BLANCO LS 016
3004511746

Unit letter Unit D - Sec 36 - T28N - R08W
San Juan, NM
PC
OGRID Number: 000778
P&A date - Oct 2013

Re: Permanent Abandonment
Well: 16 Blanco LS

CONDITIONS OF APPROVAL

Proposed Wellbore Diagram

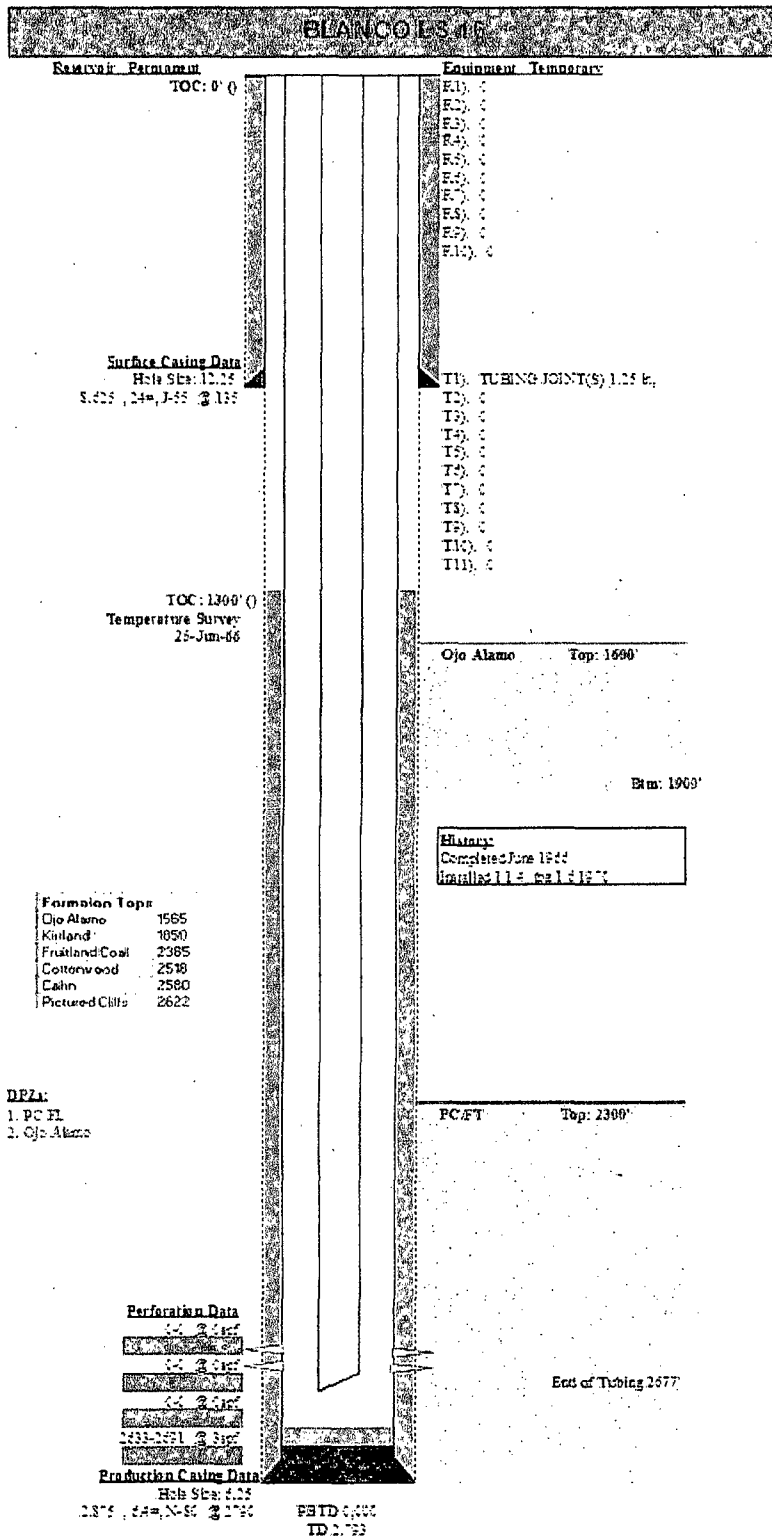
1. TOH with completion.
2. RIH with scrapper for 2-7/8" casing to 2700'
3. RIH with CIBP and set at 2600'.
4. Balance cement plug to 1300' with total 38 sks (7.8 bbl) neat G cement in 2 stages
5. PU to 1250' and reverse circulate. POOH.
6. Perforate at ~~190-200'~~ 440'
7. Pump from surface and circulate up surface casing 66 sks (13.5 bbl) neat G cement
8. Cut off well head, top off well in intermediate casing and install well marker and identification plate per regulatory requirements.
9. RD MO Location

1. Plugging operations authorized are subject to the attached "General Requirements for Permanent Abandonment of Wells on Federal and Indian Lease."
2. Farmington Office is to be notified at least 24 hours before the plugging operations commence (505) 564-7750.
3. The following modifications to your plugging program are to be made:
 - a) Place the Nacimiento/Surface plug from 440' to surface inside and outside the 2 7/8" casing.
